NO. 73/z/3

# Recall Campaign Bulletin

RECALL CAMPAIGN B.177  
Front Suspension Arms  
and Steering Lock Stops

**MARINA**

INSTALLING LOCK STOPS (21H-6390) UP TO V.I.N. 123 (INCLUSIVE)

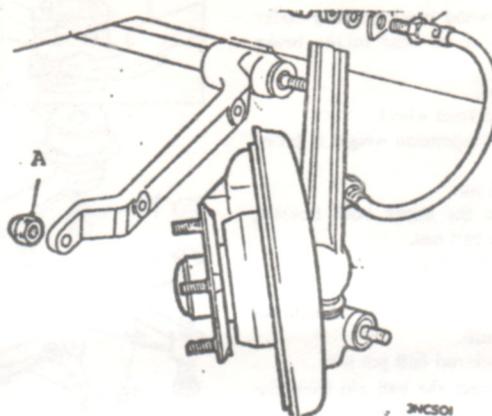
At V.I.N. 124 front wheel lock stops, in the form of a large nut at the outer lower pivot of the front suspension, were installed on production. It is necessary to install these lock stops on all Marinas prior to V.I.N. 124 and check the tie rods for damage.

1. Remove the nuts at the rear outer lower pivot of the front suspension.
2. Replace with large nuts (lock stops 21H-6390) as illustrated (A).

3. Check front wheel alignment. If TOE-OUT condition exists, this is an indication tie rod is bent, most probably at ball end under Gaiter. Remove rack and replace bent tie rod/s and ball housing lock nut/s as necessary. Operation numbers 57-25-07 and 57-65-01.

**LOWER SUSPENSION ARM ASSEMBLY**

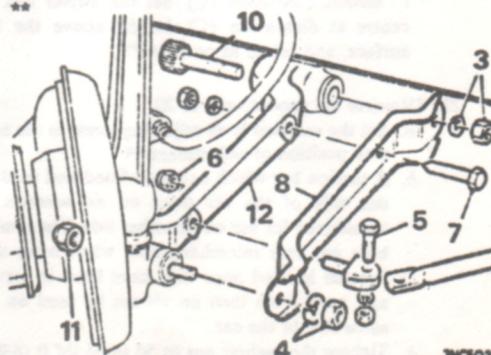
In addition, at V.I.N. 359, stronger lower suspension arms were installed on production and, although no cases of bent suspension arms have been reported, it has been decided to bring earlier vehicles (prior to V.I.N. 359) up to current production specification by installing two stronger lower arms (see service procedure attached).

REPLACING LOWER SUSPENSION ARMS UP TO V.I.N. 358 (INCLUSIVE)

1. Jack up the suspension unit under the rear lower arm, fitting suitable safety supports.
2. Remove the hub cap and road wheel.
3. Remove the nut and spring washer from the eyebolt pin.
4. Remove the front nut and spring washer from the swivel lower link pin.
5. Remove the nut, bolt and spring washer retaining the tie-rod to the tie-rod fork.
6. Remove the nut retaining the tie-rod fork and remove the fork.
7. Remove the nut, bolt and spring washer clamping the front and rear lower arms.
8. Remove the front lower suspension arm.
9. Remove the torsion bar. 60.20.42.
10. Remove the eyebolt pin.
- 11.\*\* Remove the rear nut from the swivel lower link pin.\*\*
12. Remove the lower suspension arm.

13. Reverse the procedure in 1 to 12, noting:
  - a. Tighten the tie-rod fork nut to 48 to 55 lbf ft (6.6 to 7.6 kgf m).
  - b. Tighten the tie-rod to fork nut to 22 ibf ft (3.0 kgf m).
